Report on
“Critical Analysis of the seismic Microzonation work of
Guwahati City”

By
Prof (Dr.) B.K. Rastogi
Director General
&
Dr. Kapil Mohan
Scientist-C

ISR Technical Report no.75

Fig.1: Guwahati city Boundary (existing and proposed in Landuse Plan 2025).

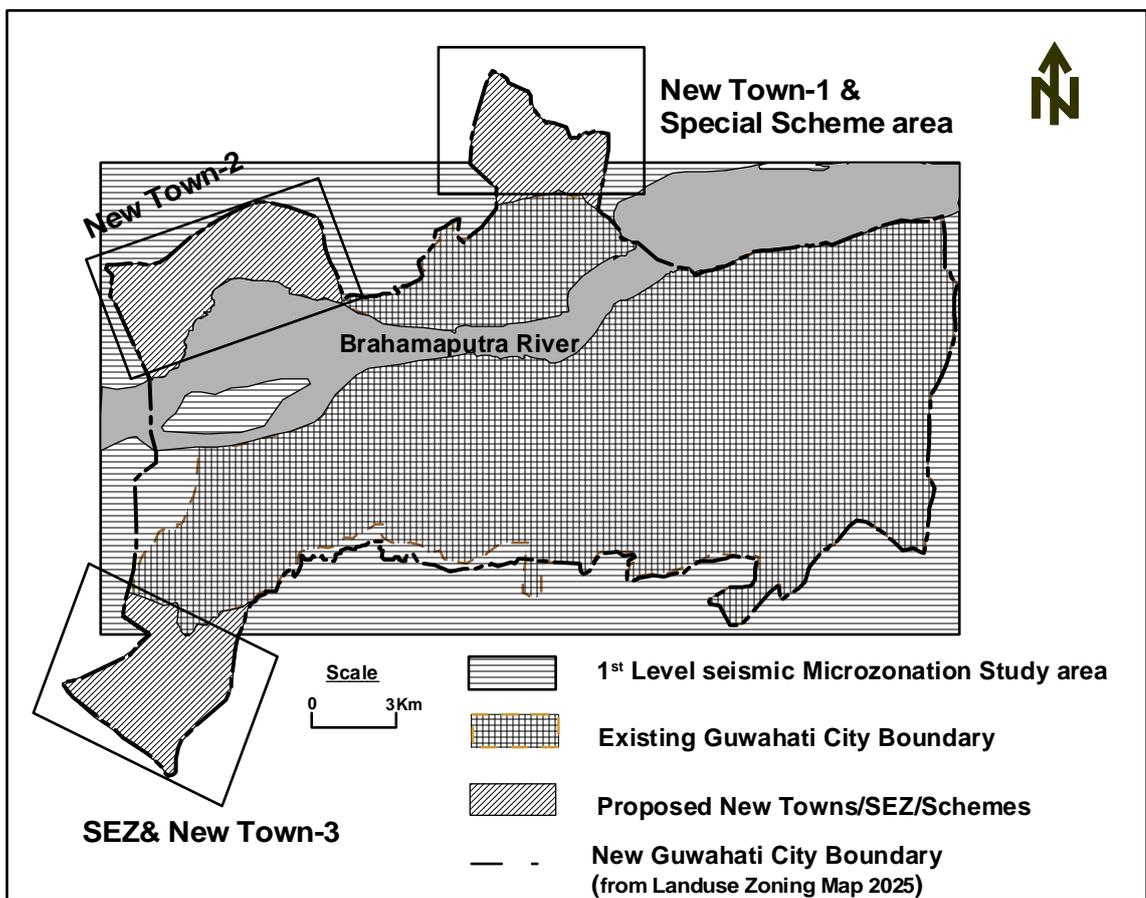
Land use Zoning Plan 2025 of Guwahati City has shown three new areas in Guwahati city (Fig.1):

- (1) New Town 1 & special scheme area in the north of the Guwahati
- (2) New Town 2 in the western part of the Guwahati city
- (3) New Town 3 & SEZ area in the South western part of the Guwahati city.

Pending suggested detailed investigation as mentioned in our report we are providing here some generalized opinion on the basis of the report on Seismic Microzonation study of Guwahati City by Department of Science and Technology, New Delhi. The points are as follows on which we broadly agree:

- (i) Most of the area falls outside DST Seismic microzonation study.
- (ii) The area is relatively more suitable for development than New Town-2 & New Town-3.
- (iii) Although most of the area is out of the DST study area but still chances of ground acceleration of the order of 0.15 to 0.3g is expected based on the value estimated in part of the area. However, the prescribed ground acceleration for MCE is 0.36 as per the existing earthquake code and the same is in implementation by the competent development authority already.

- (i) Although the area is covered in DST Seismic microzonation study but only one borehole (no. 163) is drilled in this part. Hence it is not a well studied zone.

- (ii) The area is situated on Quaternary alluvium (Bordang surface) and shown a PGA of the order of 0.3 to 0.75g (0.3-0.45g in the northeastern and eastern part, 0.45 to 0.60g in the central part while 0.6 to 0.75g in the western and southwestern part of the area. The PGA values are amplified PGA values due to site response characteristics expected in this area. These PGA values are not to be used directly for design force calculations. What is important is the micro-level mapping of predominant frequency in this area to advise on the risk level associated with type of structures. It can be advised to build structures with height restrictions so that the natural frequencies of these structures (having heights in certain range) will be isolated from the predominant frequencies at which amplifications are predicted in microzonation.

- (iii) Site response/amplification of the order of 2.5 to 4.5 is mentioned in this part of the area (Chapter 3, Fig 3.9).
- (iv) The area is very close to the river hence highest flood level should be checked. The Chances of Liquefaction will be high in this zone as the area is situated on Quaternary soil and on the Bank of Brahmaputra River. Liquefaction analysis is a must for any development in this area and the foundation design has to be done extremely carefully. In addition the area is susceptible to erosion so the township should be carefully planned.

- (i) The area is the south-west of the Guwahati city and most of the area falls outside DST Seismic microzonation study.
- (ii) From the Geomorphological Map (Chapter 5, Fig 5.3), this area falls on Quaternary alluvium. The site amplification of 3(average from extrapolation of results (Chapter3, Fig 3.9)) is expected.
- (iii) The area falls 30-50km east of the epicenter of Mw 8.7, 1897 Assam earthquake. From the present study (on extrapolation) one can expect a PGA of the order of 0.6 to 0.75g. The PGA values should be considered while designing structures in this area.
